TOWN OF RIDGWAY
DUCTILE IRON PIPE REPLACEMENT PROJECT
ADDENDUM NO. 1

To all prospective bidders of the Ridgway Ductile Iron Pipe Replacement Project contract for which bids were to be received until 4 pm, Thursday June 27, 2024 at Ridgway Town Hall.

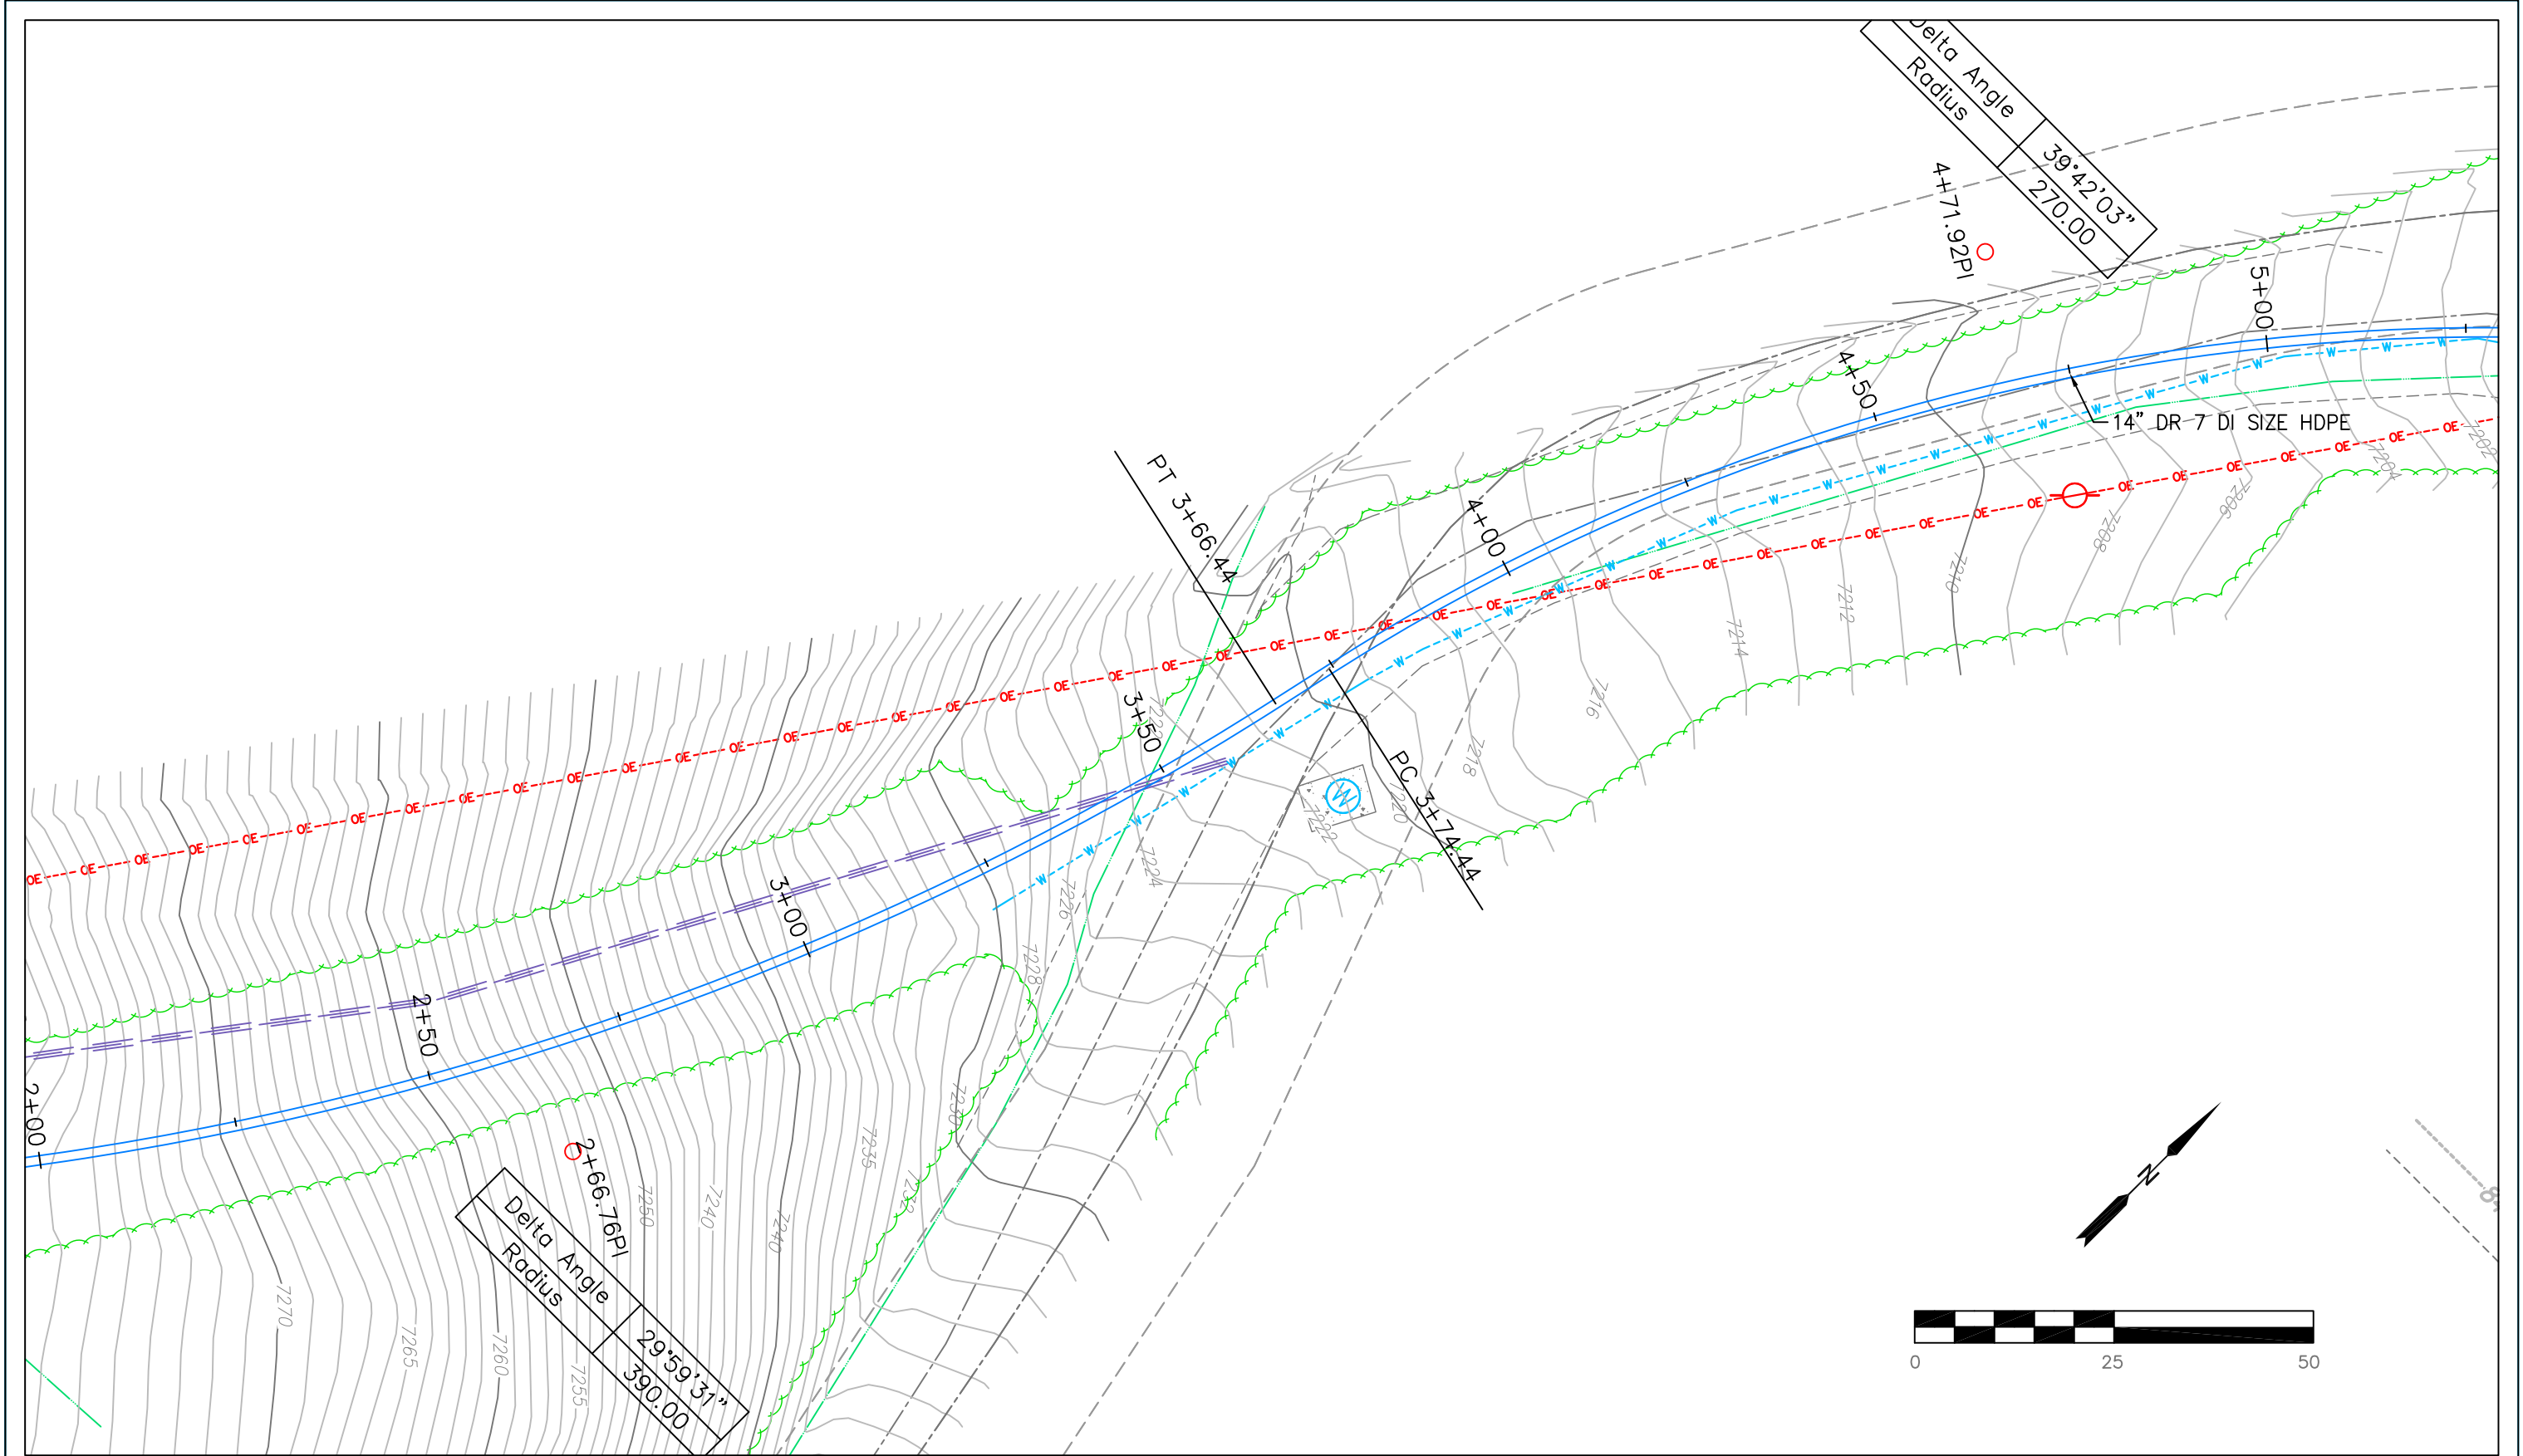
REPLACE: Replace Sheet P-2 and P-9 with the attached copies of Sheet P-2 and P-9 which shows the topographic lines.

<table><tr> <th colspan="2">Sheet Revisions</th> </tr><tr> <td> </td> <td>Addendum 1 - reprint with topographic lines.</td> </tr></table>

P3
 Add #1

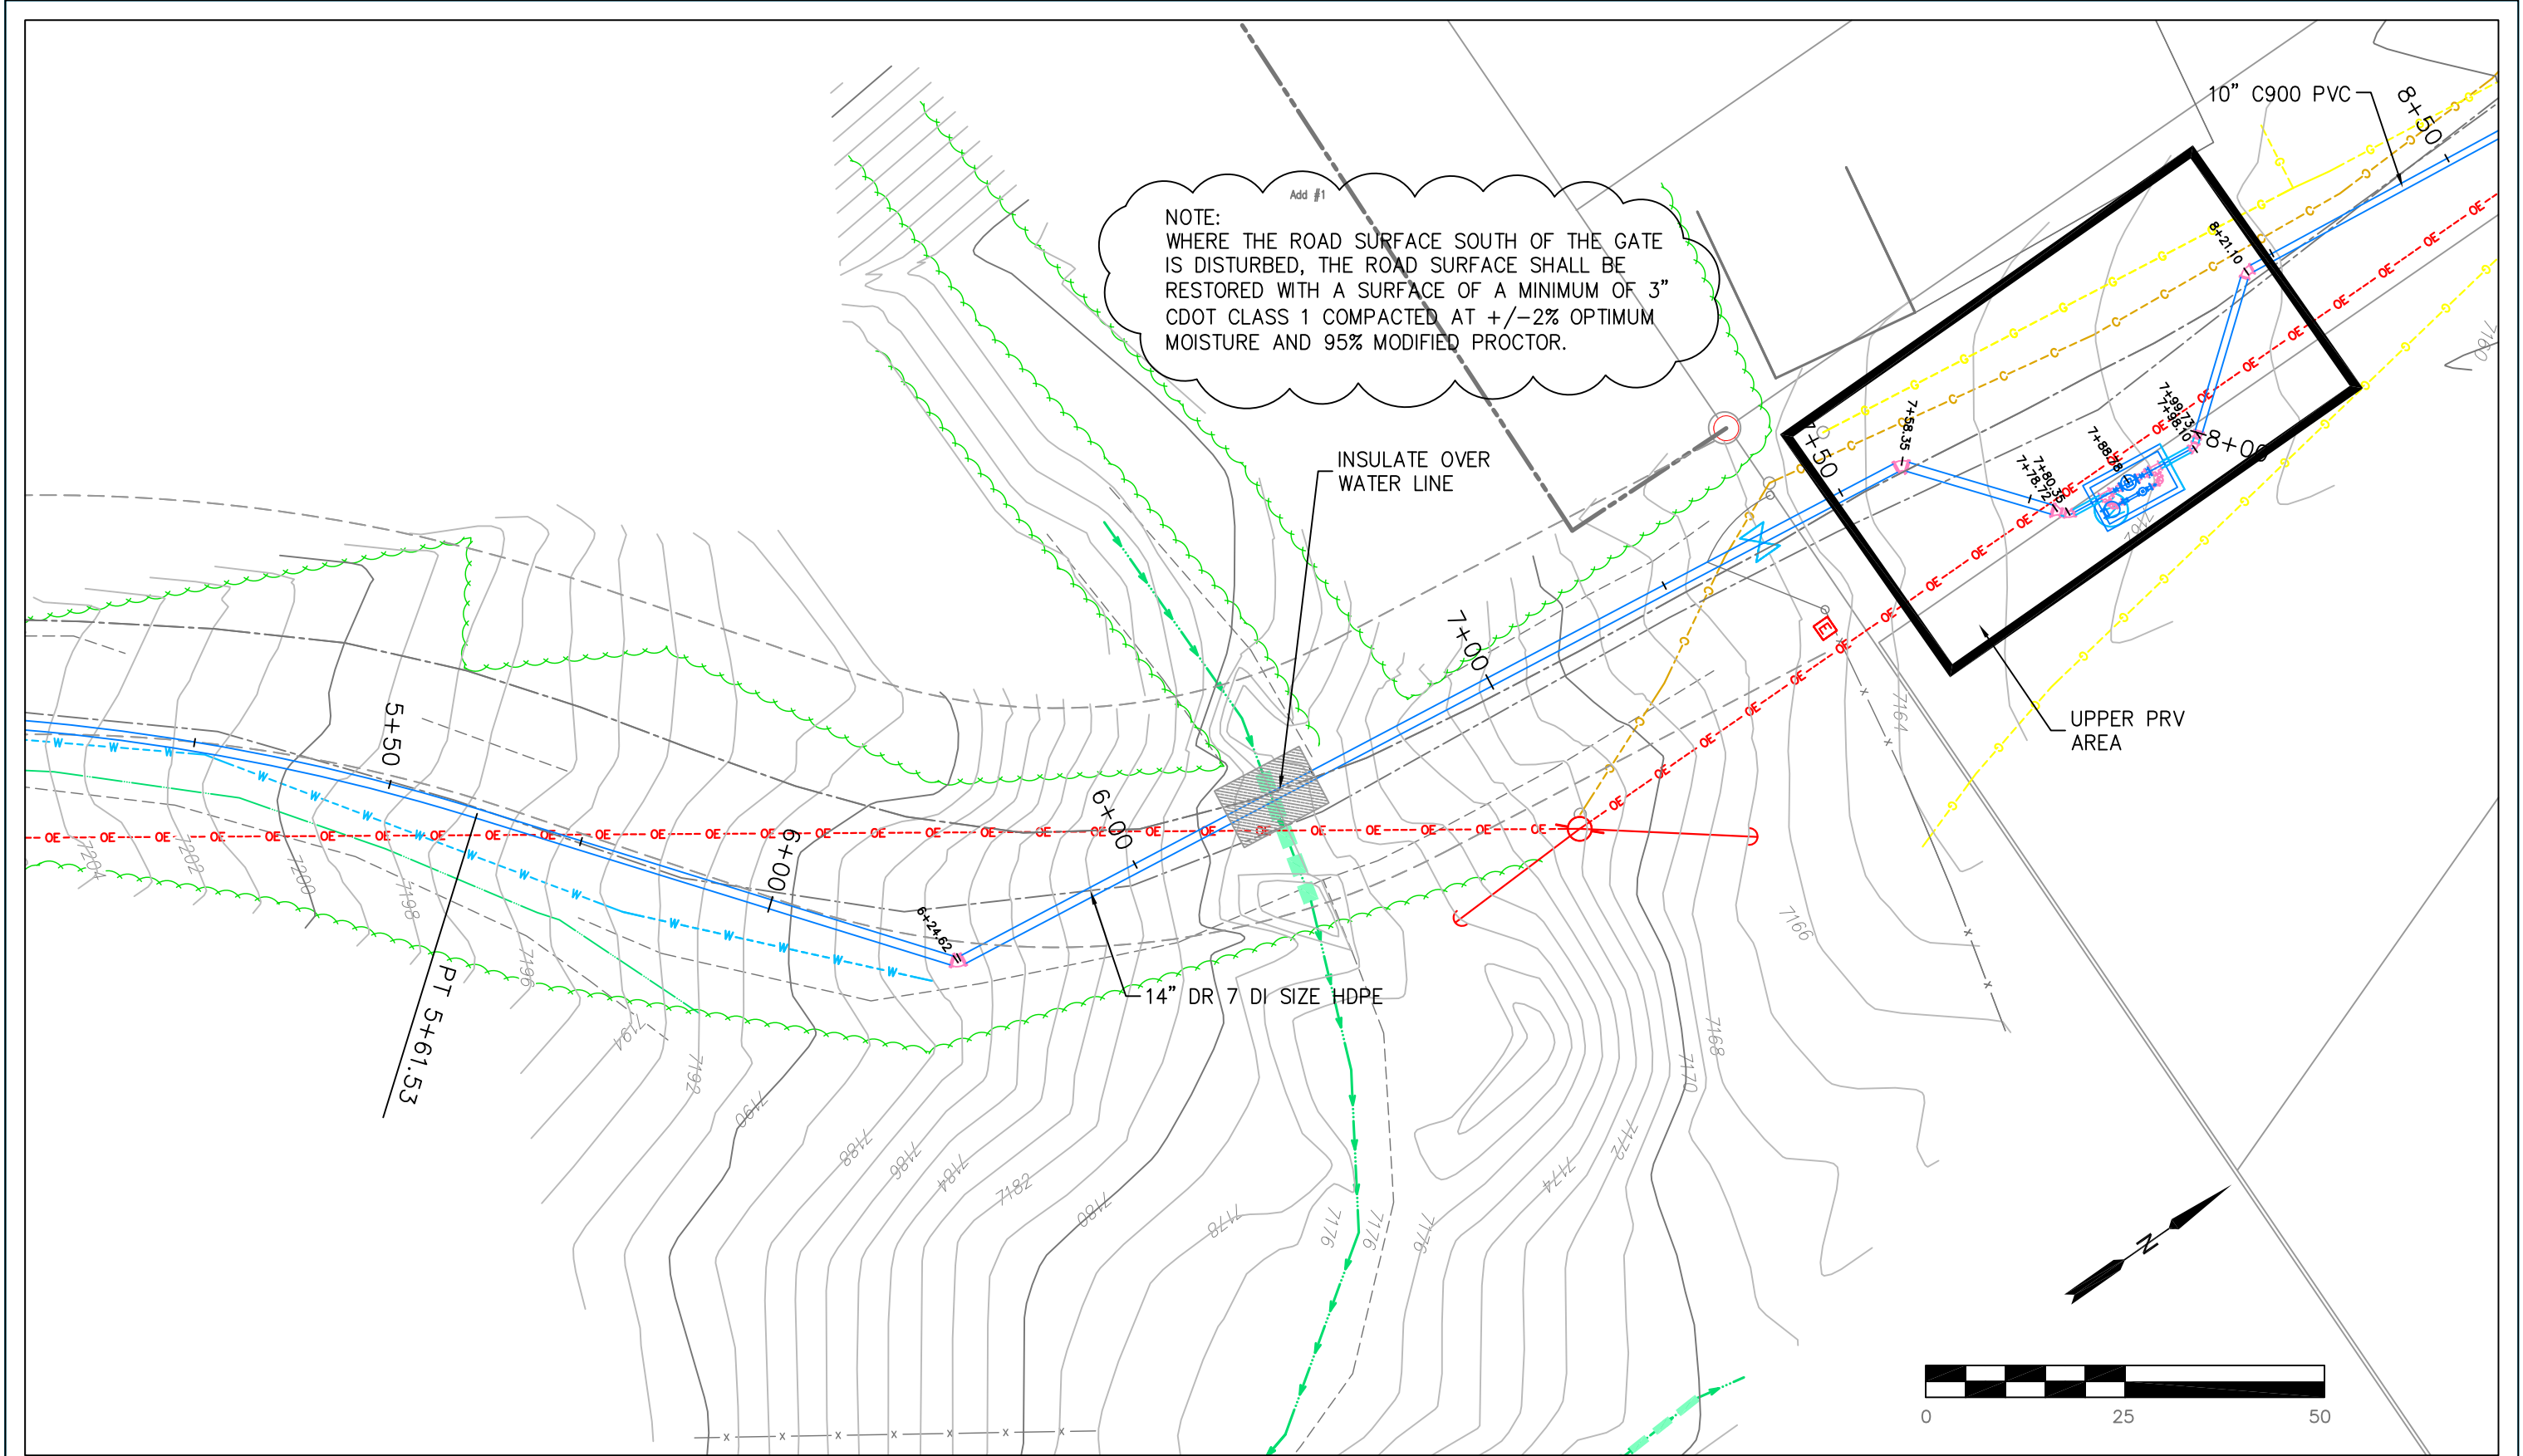
REPLACE: Replace Sheet P-3 with the attached copy of Sheet P-3 which shows the topographic lines and adds a note about road restoration. .

Addendum 1 - Reprint with topographic lines. Add note about road surface

NOTE:
 WHERE THE ROAD SURFACE SOUTH OF THE GATE
 IS DISTURBED, THE ROAD SURFACE SHALL BE
 RESTORED WITH A SURFACE OF A MINIMUM OF 3"
 CDOT CLASS 1 COMPACTED AT +/-2% OPTIMUM
 MOISTURE AND 95% MODIFIED PROCTOR.

P9
 Add #1
 03/14/24

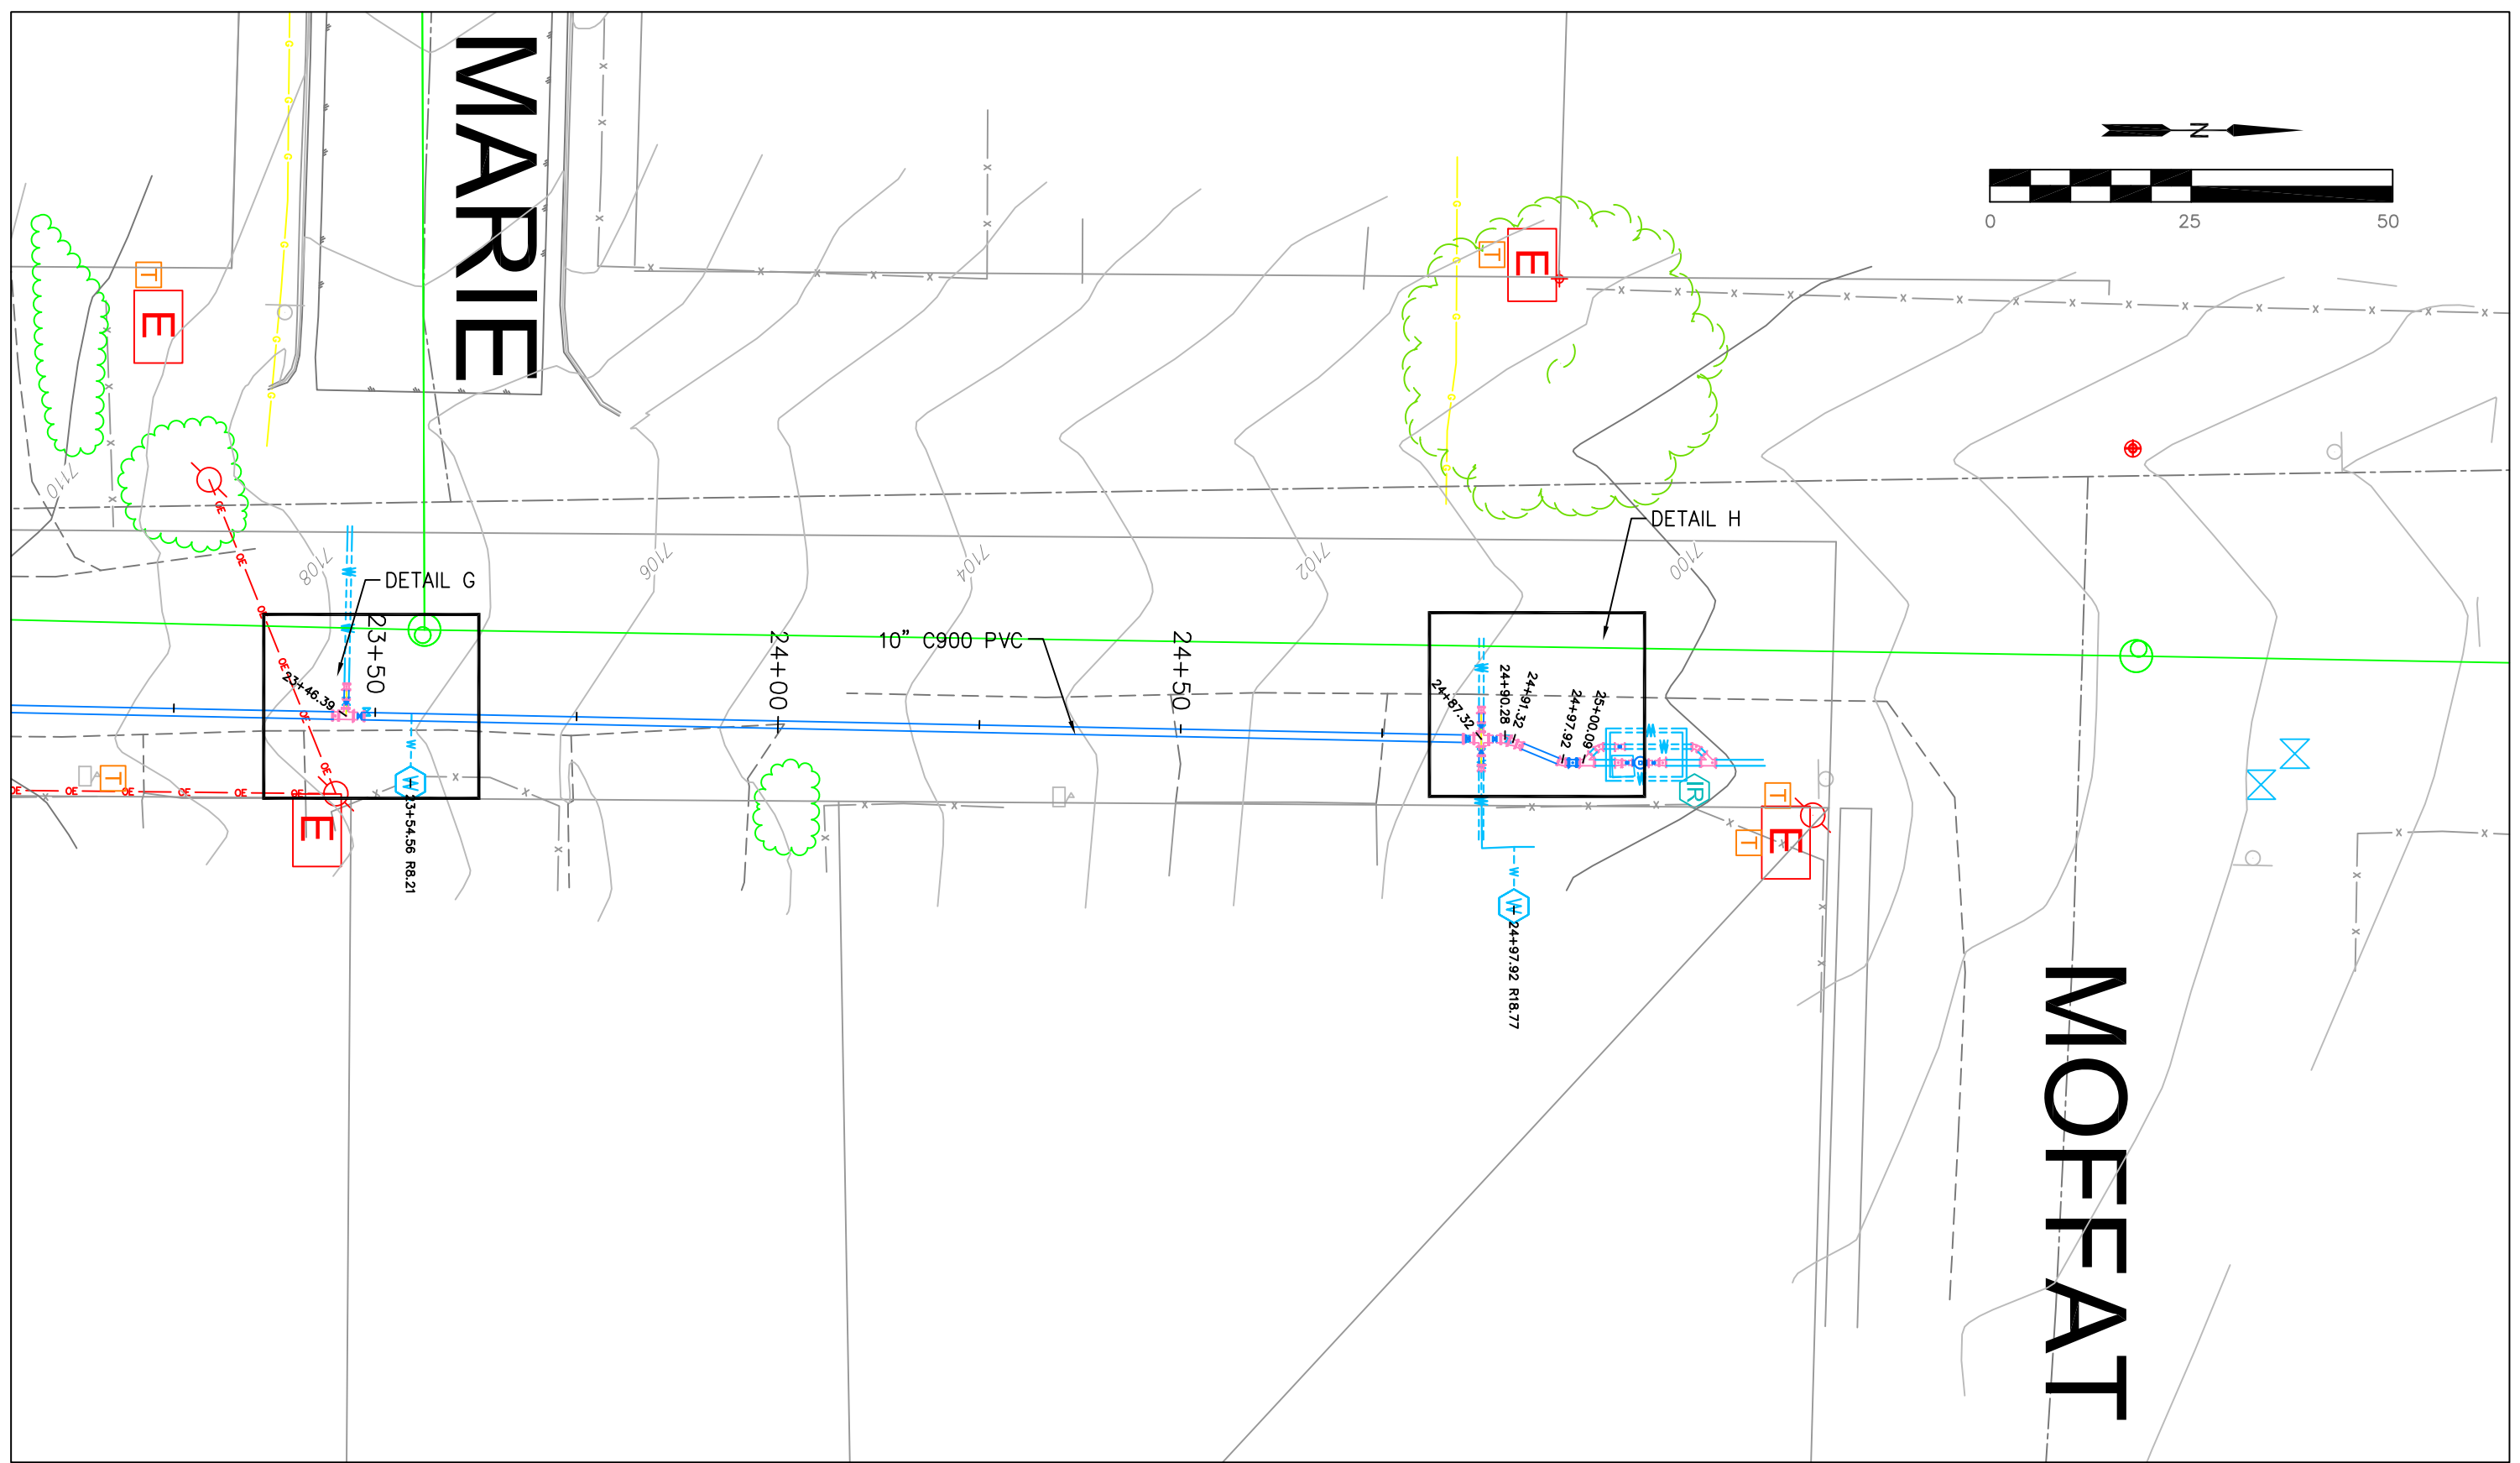
Sheet Revisions	
00000	Addendum 1 - reprint with topographic lines.
